C74-6502 PCB Patch Guide (v1.0 Boards)

The following patches were applied to the C74-6502 V1.0 prototype boards during debugging. Patches are divided into three categories:

Patch 1:

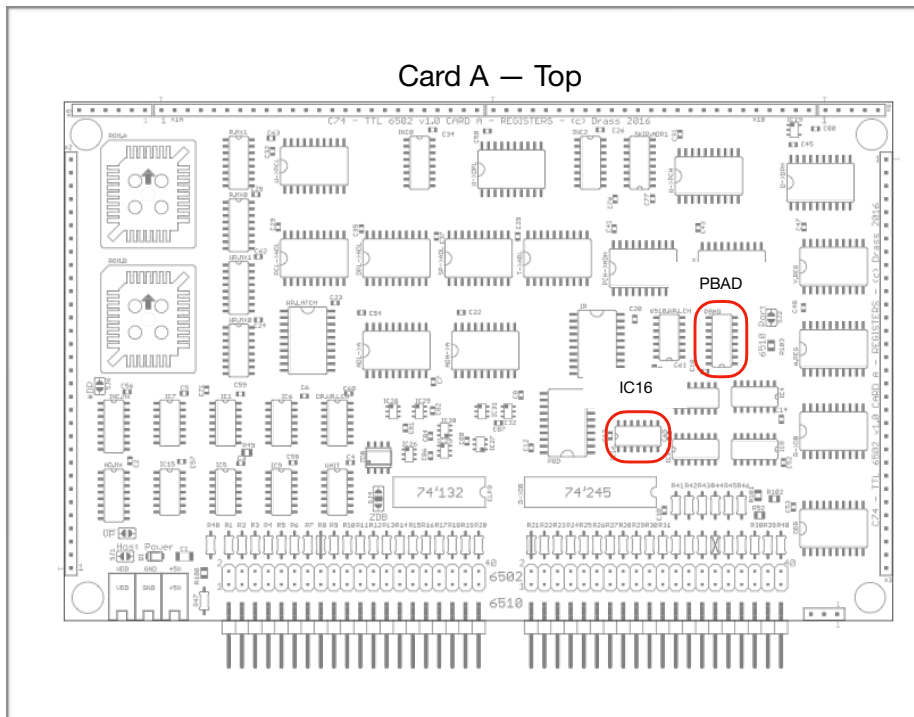
1. 6510 PORT – REVERSED PINS ON PBAD, INVERTED POLARITY OF /BE

Description: The v1.0 boards had certain pins reversed on the PBAD IC (part of the 6510 port). This patch makes the correct connections on PBAD, and skips the inverter on PBAD.5 to have the right polarity.

Rationale: This patch must be made in order for the 6510 port to work properly

- Card A: PBAD.11 (LIFT) → PBAD.10 (PAD)
- Card A: PBAD.10 (LIFT) → PBAD.11 (PAD)
- Card A: PBAD.7 (LIFT) → PBAD.9 (PAD)
- Card A: PBAD.9 (LIFT) → PBAD.7 (PAD)
- Card A: IC16.3 (LIFT)
- Card A: IC16.3 (PAD) → PBAD.5 (LIFT)

Patch 2: Correct inputs of T->R

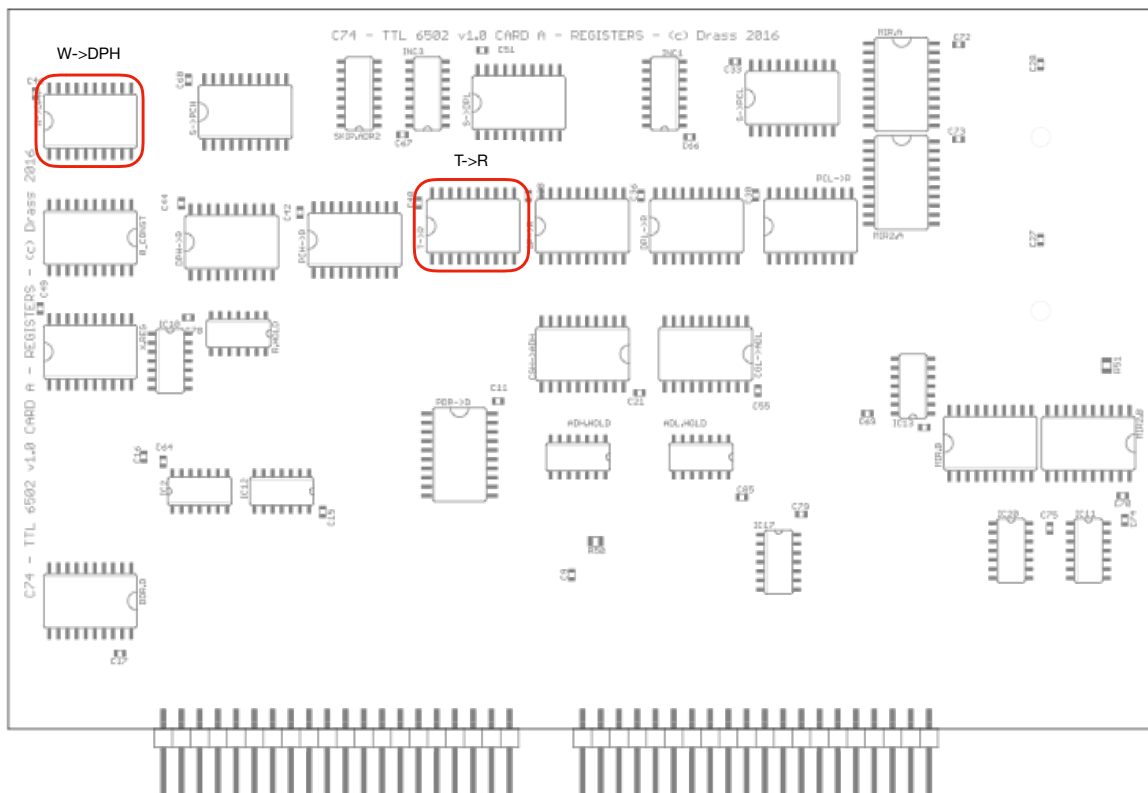
2. T->R INPUTS PINS REVERSED

Description: The v1.0 boards had pins on the T->R buffer reversed. This patch corrects these connections.

Rationale: This patch must be made for the CPU to work properly.

- Card A: T->R.7 (PAD) → T->R.6 (LIFT)
- Card A: T->R.8 (PAD) → T->R.7 (LIFT)
- Card A: T->R.9 (PAD) → T->R.8 (LIFT)
- Card A: W->DPH.9 → T->R.9 (LIFT)

Patch 2A: Correct outputs of S->PCH

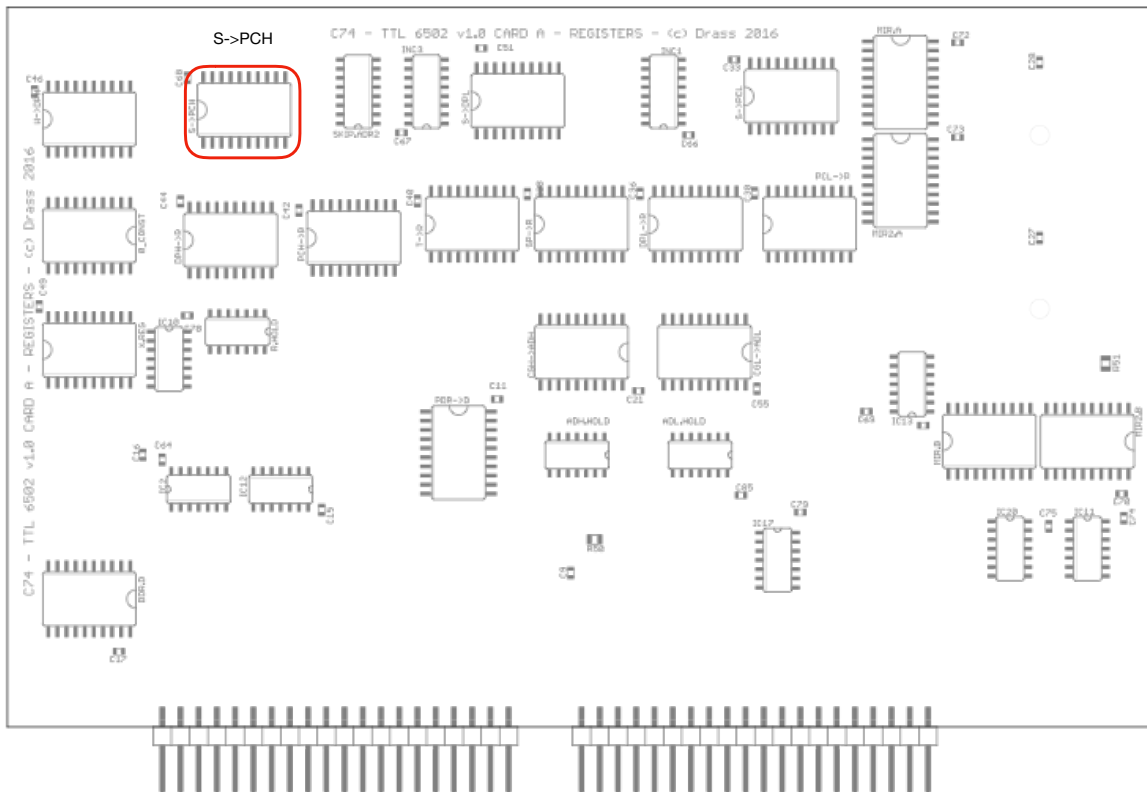
2A. S->PCH OUTPUT PINS REVERSED

Description: The original schematics had pins on the S->PCH buffer reversed. This patch corrects there connections.

Rationale: This patch must be made for the CPU to work properly

- Card A: S->PCH.11 (LIFT) → S->PCH.18 (PAD)
- Card A: S->PCH.12 (LIFT) → S->PCH.17 (PAD)
- Card A: S->PCH.13 (LIFT) → S->PCH.16 (PAD)
- Card A: S->PCH.14 (LIFT) → S->PCH.15 (PAD)
- Card A: S->PCH.15 (LIFT) → S->PCH.14 (PAD)
- Card A: S->PCH.16 (LIFT) → S->PCH.13 (PAD)
- Card A: S->PCH.17 (LIFT) → S->PCH.12 (PAD)
- Card A: S->PCH.18 (LIFT) → S->PCH.11 (PAD)

Patch 4:

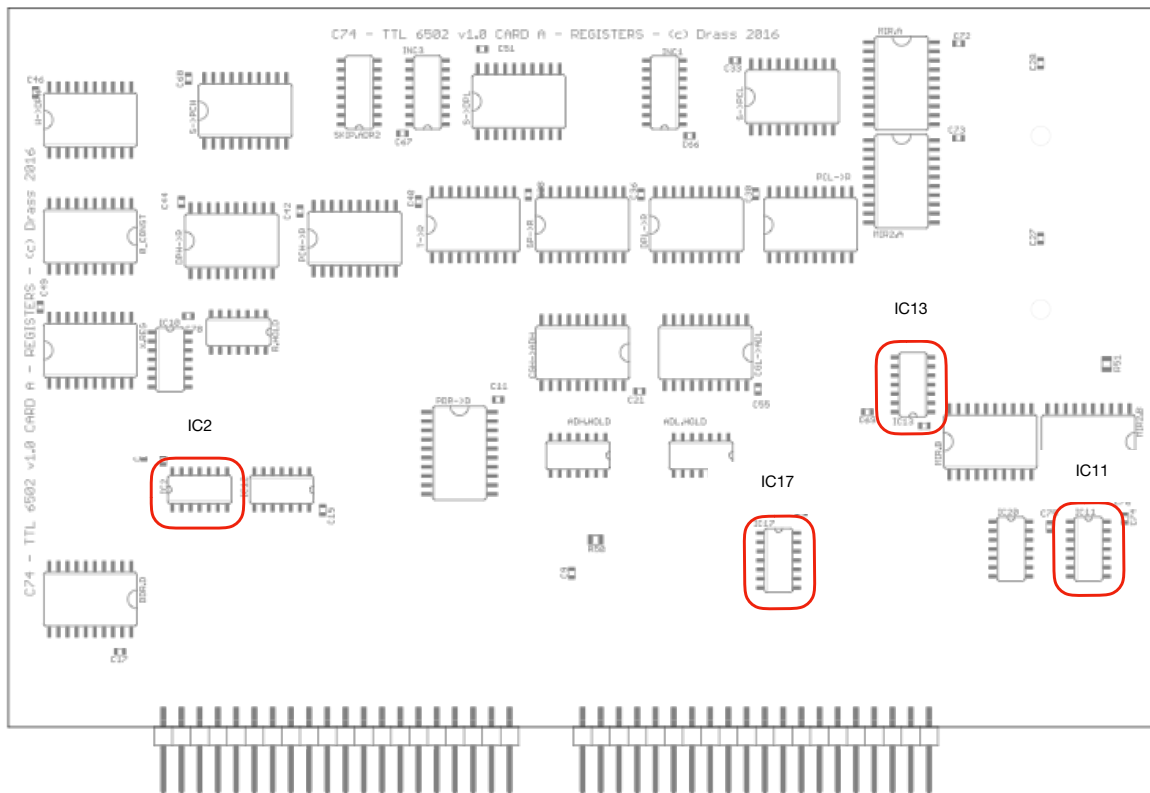
4. R/W TAKES TOO LONG BEYOND 16MHZ

Description: Speed tests revealed that the CPU takes too long to generate R/W when operating above 16MHz. This patch reduces the propagation delay for the R/W signal by taking one gate out of the path.

Rationale: This patch should be applied if operation at clock-rates above 16MHz is planned.

- Card A: IC11.10 → IC17.9 (LIFT)
- Card A: IC13.3 → IC17.10 (LIFT)
- Card A: IC17.8 → IC2.12
- Card A: IC5.10 (LIFT)

Patch 5:

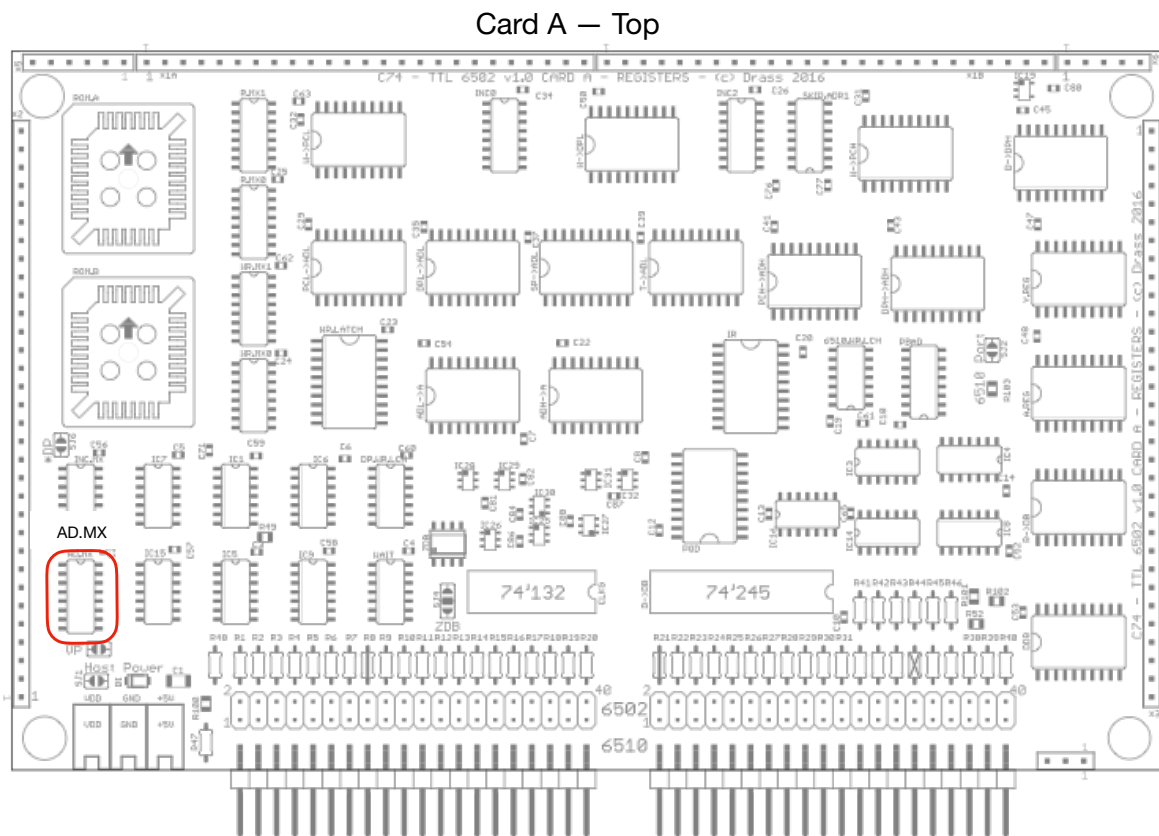
5. COMPATIBILITY WITH BUS SHARING SCHEMES

Description: The C74-6502 was designed to drive the bus during Phase 1 only. This is in order to avoid transient bus collisions at high speeds. Unfortunately, this bus scheme is not compatible with systems where the CPU shares control of the bus with other peripherals (such as on the Commodore 64 and others). This patch will cause the CPU to drive the bus during Phase 2 as well as Phase 1. This will lead to short transient collisions on the bus during state transitions, but these are benign and can be safely ignored.

Rationale: Required for operation in machines that implement bus sharing schemes (e.g. Commodore 64)

Note: Need to test whether applying this patch inhibits operation at the highest clock-rates. If so, consider replacing ADL.A and ADH.A 74CBT3245s with 74AC541s.

- Card A: AD.MX.5 → AD.MX.4 (LIFT)
- Card A: SP→R.10 → CGH→ADH.1 (LIFT)

Patch 6:

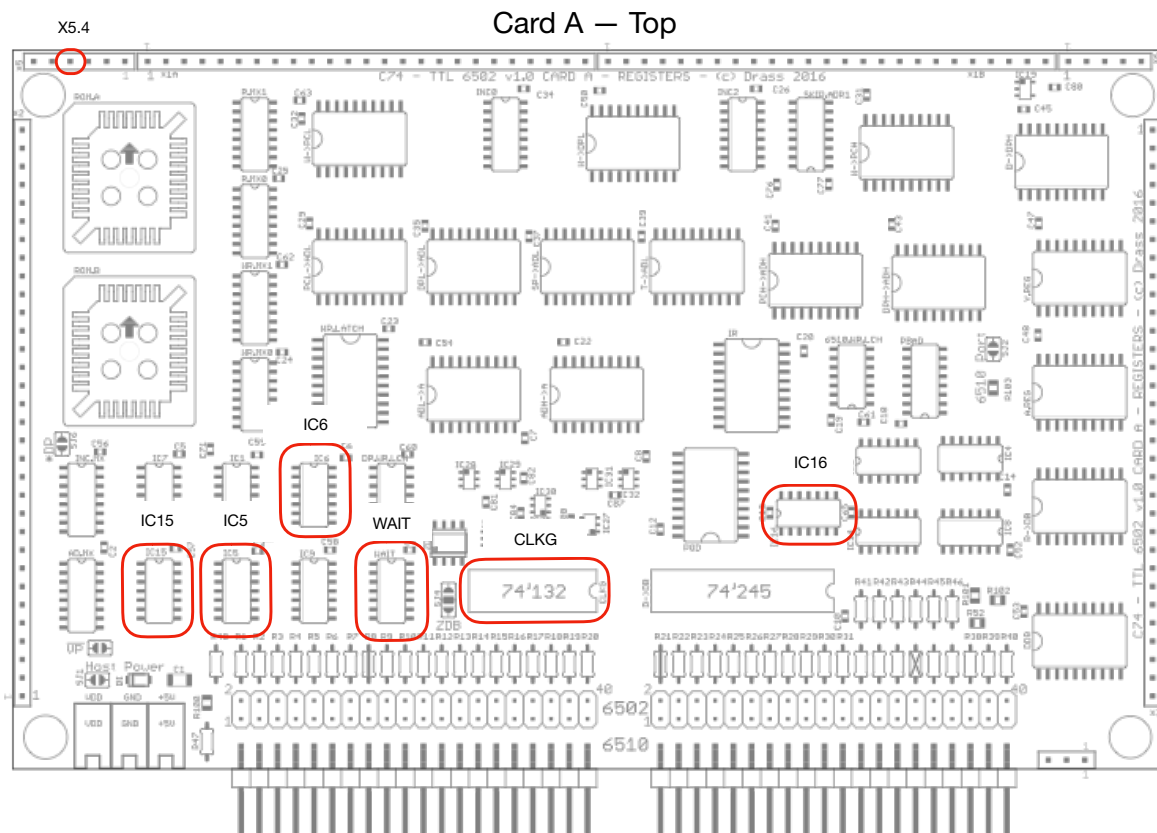
6. RDY TAKES EFFECT ONE CYCLE TOO LATE AND RDY NMOS 6502 COMPATIBILITY

Description: The RDY signal is meant to pause the CPU during Phase 2 of the cycle in which it is detected. Instead, the TTL CPU was pausing during Phase 1 of the following cycle. In addition, RDY should not pause the CPU on reads when emulating the NMOS 6502 but should do so for the 65C02. This patch will cause the RDY to correctly pause the CPU during Phase 1, and its behaviour will adjust automatically based on the active instruction-set.

Rationale: This came up in testing when accessing devices that require wait-states, as well as on the Commodore 64 where timing sensitive applications expect strict adherence to the NMOS 6502 behaviour.

- Card A: CLKG.4 → CLKG.5 (LIFT)
- Card A: CLKG.5 (SOCKET) → WAIT.2 (LIFT)
- Card A: CLKG.6 → IC6.9 (LIFT)
- Card A: IC6.11 → IC6.10 (LIFT)
- Card A: X5.4 → IC16.3 (LIFT)
- Card A: IC16.4 → IC6.12 (LIFT)
- Card A: IC15.12 → IC6.13 (LIFT)
- Card A: IC6.8 → WAIT.10 (LIFT)
- Card A: WAIT.4 → WAIT.1 (LIFT)
- Card A: WAIT.6 (LIFT)
- Card A: WAIT.5 → WAIT.6 (PAD)
-

Patch 7: Part 1

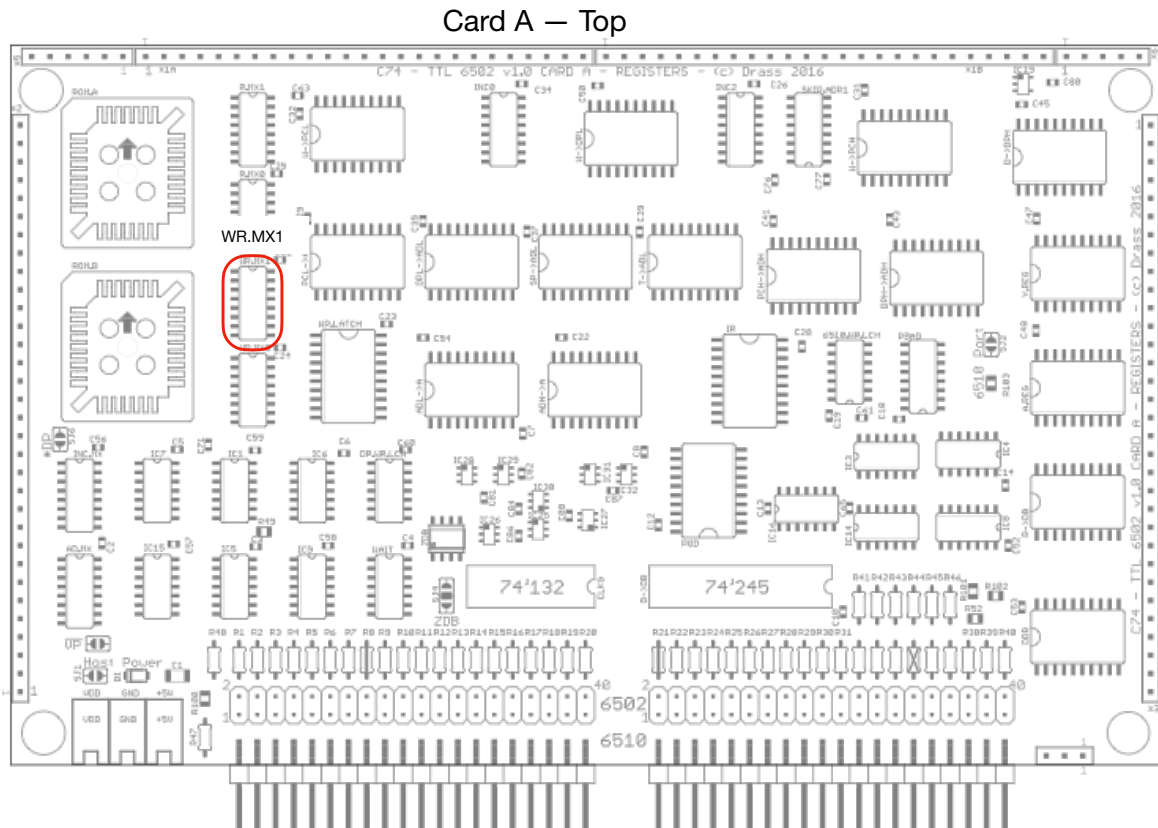
7. NMOS 6502 MODIFY CYCLE WRITE

Description: The NMOS 6502 performs a Read-Write-Write sequence for RMW instructions (INC, DEC, ASL, etc.). The C74-6502 was designed to duplicate the 65C02 behaviour, which is Read-Read-Write. This patch will cause a Write to be performed during the Modify (middle) cycle when the NMOS 6502 instruction-set is selected.

Rationale: Several Commodore 64 games were found to rely on a Modify-Cycle-Write to clear the raster interrupt on the VICII chip. This is fairly common practise on more advanced games. Most 65C02 systems will work when the NMOS Modify-Cycle-Write behaviour is in effect. However, the reverse is not true. It is therefore recommended that the patch be made unless operation on NMOS 6502 systems is not planned.

WARNING: This patch disables “H+1” undocumented opcodes (see C74-6502 datasheet p. 21). These opcodes are classified as “unstable”, meaning that they produce different results on different 6502 systems. Their use is extremely rare. The C74-6502 implementation is detailed in the datasheet (Appendix F). They are not supported at clock-rates above 14MHz.

- Card A: WR.MX1.9 (LIFT)

Patch 9: Part 1

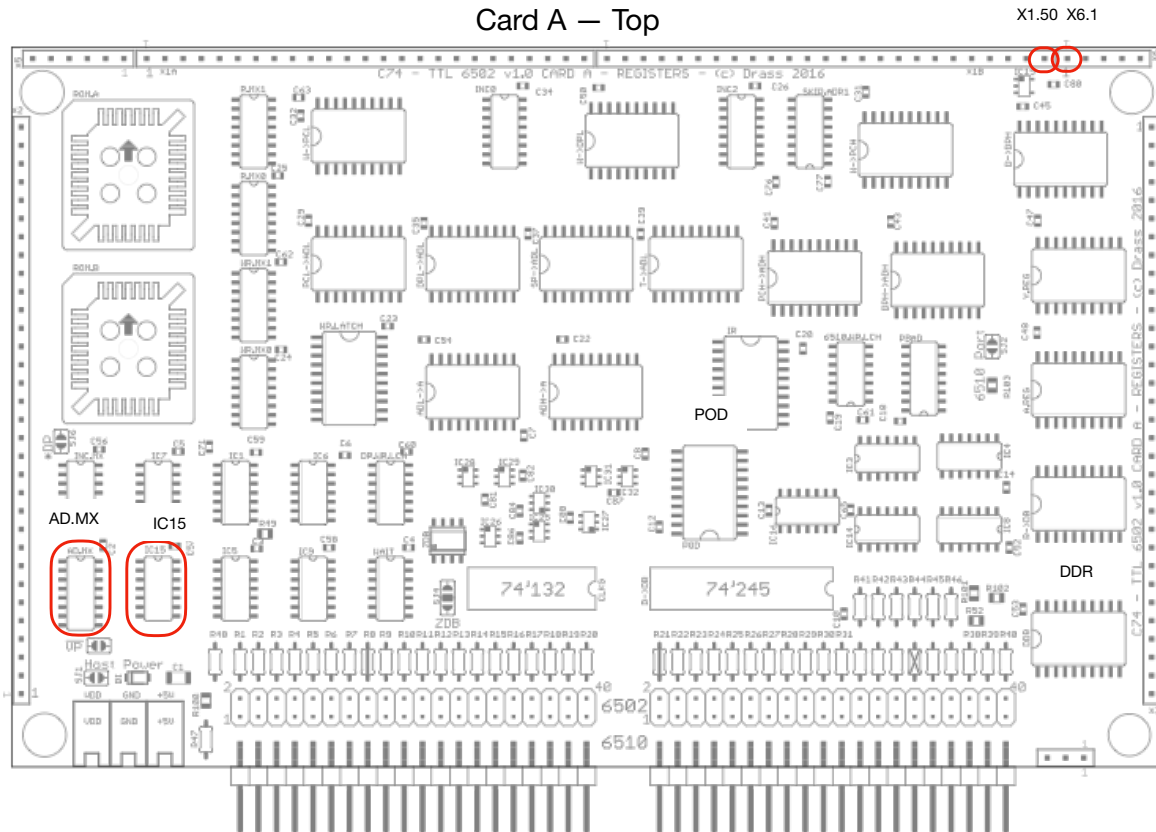
9. NMI INCORRECTLY INTERRUPTS IRQ

Description: This patch fixes a bug where the CPU will lose an IRQ if an NMI happens to arrive just as the IRQ vector is being fetched by the CPU.

Rationale: This bug caused problems for a couple of Commodore 64 games which rely on strict processing of IRQs and also have frequent NMIs occurring. The patch is recommended for strict compatibility with NMOS 6502.

- Card A: AD.MX.7 → X1.50
- Card A: IC15.1 → IC15.13 (LIFT)
- Card A: X6.1 → POD.1 (LIFT) → DDR.1
